# Wisconsin Department of Transportation

**Proposal #10: 5808-00-73, WISC 2021438**  
**Reedsburg – Lyndon Station**  
**Sauk County Line to CTH J**  
**CTH HH**  
**Juneau County**

This is Addendum No. 01, which provides for the following:

**ADDENDUM NO. 01**

Addendum No. 01  
 ID 5808-00-73  
 Revised Sheet 5  
 July 28, 2021

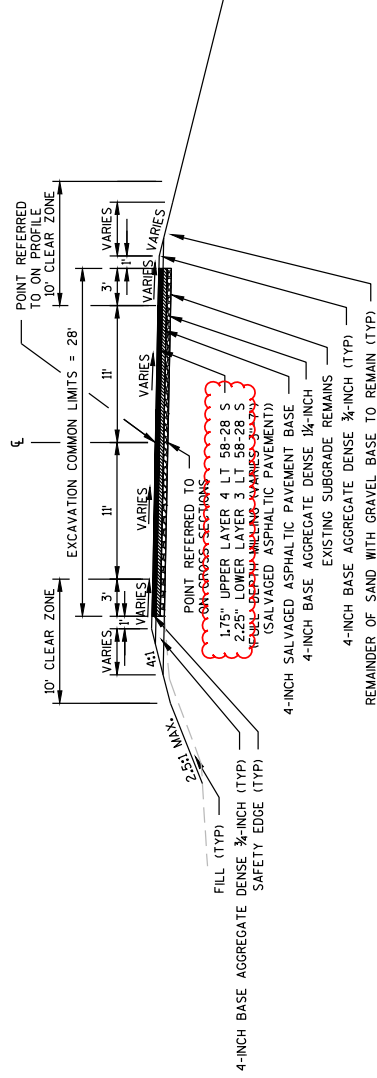
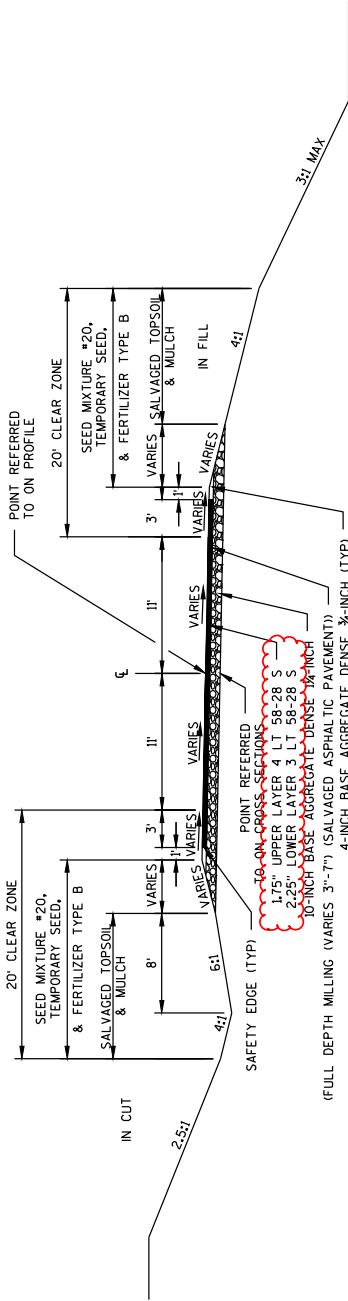
Revised Plan Sheets	
Plan Sheet	Plan Sheet Title (brief description of changes to sheet)
5-8	Typical Sections – Changed upper layer to HMA Pavement 4 LT 58-28 S
10,11	Construction Details – Added to side road detail bid items and changed labels to “HMA Pavement”
31	Miscellaneous Quantities – Added HMA Pavement 4 LT 58-28 S, removed PWL table
